Access Compliance Report

Public Rights-of-Way

(Curb Ramps)

Intersection ID: 13620	Main Street: SHENANDOAH_AV	Cross Street: THE_PLAZA	Location: E
ADA ID: CD881B491CC1	Ramp Type: BlendTrans1	Initial Pass/Fail: Fail	Overall Compliance: No
Severity Score: 8.75			
Codes/Mitigation Info/Possible Solution		Field Measurements/Component Compliance

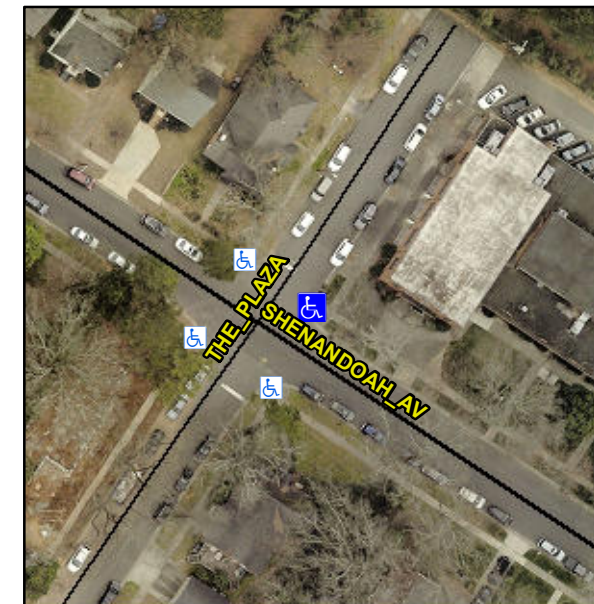
Not Found, R304.5.1

Compliance	Description	Data	Compliance	Description	Data
N/A	Ramp Length (in)	93.5	Yes	BlendTrans Slope (%)	4.2
No	Ramp Width (in)	47.5	Yes	BlendTrans XSlope (%)	0.2
N/A	Flare Type LT	N/A	N/A	Flare Type RT	N/A
N/A	Flare Slope LT (%)	N/A	N/A	Flare Slope RT (%)	N/A
N/A	Flare Traversable LT?	N/A	N/A	Flare Traversable RT?	N/A
N/A	Landing Length (in)	N/A	N/A	DWS Provided?	N/A
N/A	Landing Width (in)	N/A	N/A	DWS Contrast?	N/A
N/A	Landing Slope (%)	N/A	N/A	DWS Length (in)	N/A
N/A	Landing X Slope (%)	N/A	N/A	DWS Full Width?	N/A
N/A	Landing Curb? (Y/N)	N/A	N/A	DWS Offset (in)	N/A
N/A	Shared Landing?	N/A			
N/A	Gutter Ponding?	N/A	N/A	Gutter Slope (%)	N/A
N/A	Gutter Lip Ht (in)	N/A	N/A	Gutter X Slope (%)	N/A
N/A	Painted X Walk1?	No	N/A	Painted X Walk2?	No
	X Walk 1 Direction	To NW		X Walk 2 Direction	To SW
	X Walk 1 Width (in)	N/A		X Walk 2 Width (in)	N/A
	X Walk 1 Slope (%)	0.5		X Walk 2 Slope (%)	0.3
	X Walk 1 X Slope (%)	0.1		X Walk 2 X Slope (%)	0.6

N/A	Ramp inside XWalk1?	N/A	N/A	Ramp inside XWalk2?	N/A
	Road Slope (%)	1.3		Clear Space?	N/A
	Road X Slope (%)	0.3	N/A	Clear Space to XWalk (in)	N/A
N/A	Any Obstructions?	N/A	N/A	Storm Grate/Utility Hazard?	N/A
	Obstruction Type			Storm Grate/Utility Type	
		N/A			N/A
			Yes	Surface Condition? (G/P)	Good
			No	Curb Slope (%)	21.0

Remove & Replace Curb Ramp With Two New Directional Ramps or Equivalent.
